Addendum #2

**Bid Opportunity: 5219 - RAAC St. Margaret Mary
CES**

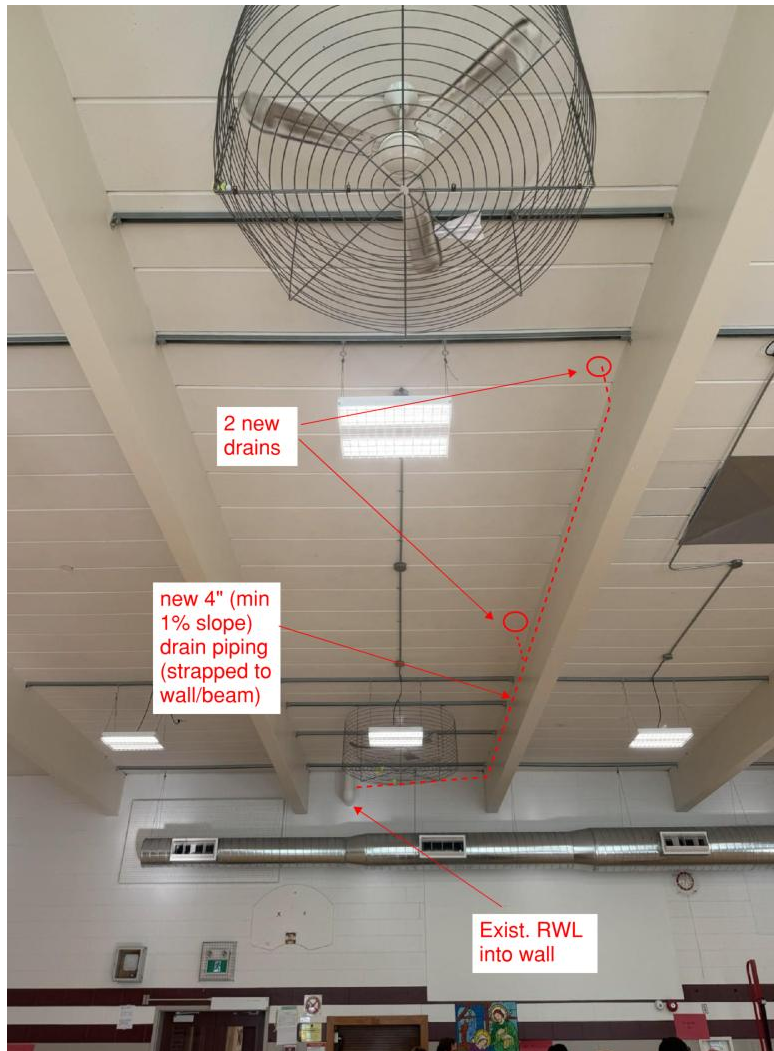
Please provide a mechanical drawing to show the routing of the RWL piping and any other work that will be necessary.

There is minimal roof drain piping required and as such a drawing is not being provided. Here is a photo to help illustrate the requirement (one of the 2 locations). Refer to Drawing S1.0 for drain locations. Due to the nature of the room, pipe must be adequately secured to the beam and wall.
